JABIRU AIRCRAFT PTY LTD

SERVICE BULLETIN: JSB 012-5

Issue: 5

Subject: Jabiru Engine Flywheel Attachment

Figure 2 - Plain washers compared to Nordloc washers

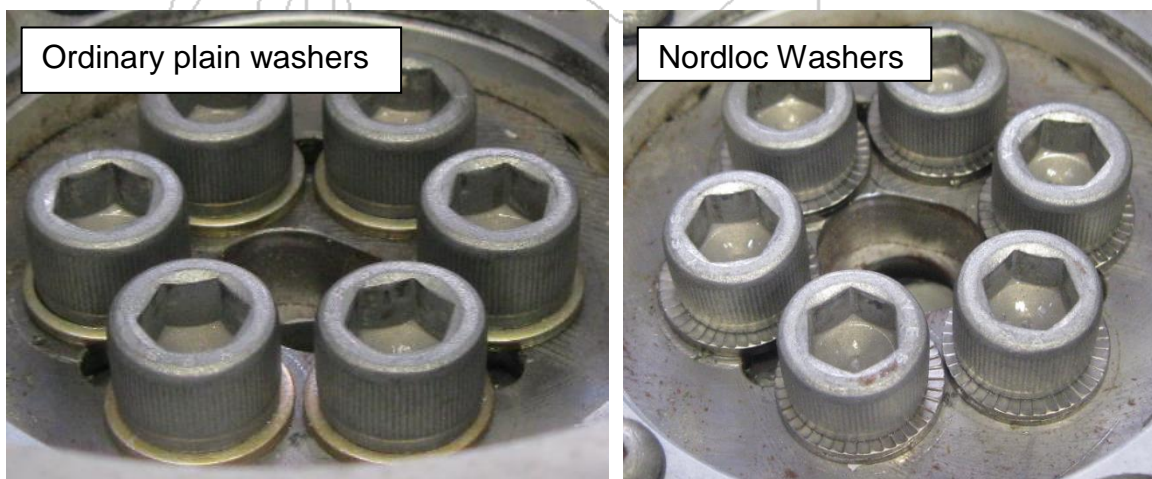
This revision of this service bulletin also acts to inform maintainers and operators of a design change to the flywheel connection which should be implemented on existing engines whenever flywheel bolts are replaced (i.e. at the intervals specified in JEM0002 or at overhaul).

Flywheel screws must now be installed using Nordloc washers (replacing the previous installation which used either plain or Belleville washers). Jabiru engines of any and all flywheel configurations (as defined in Table 1) should now use Nordloc washers. These washers are easily identified via visual inspection as shown below in Figure 2.

Refer to the Jabiru Engine overhaul manual JEM0001 (always check for the latest revision) for the installation procedure of flywheel capscrews using Nordloc washers. The major difference in installation is that bolts installed with Nordloc washers **must not be installed with Loctite**. The torque setting is also different for capscrews installed with these washers.

When Nordloc washers are used on an aluminium surface a steel plate must be used to protect the aluminium surface. These are available from Jabiru.
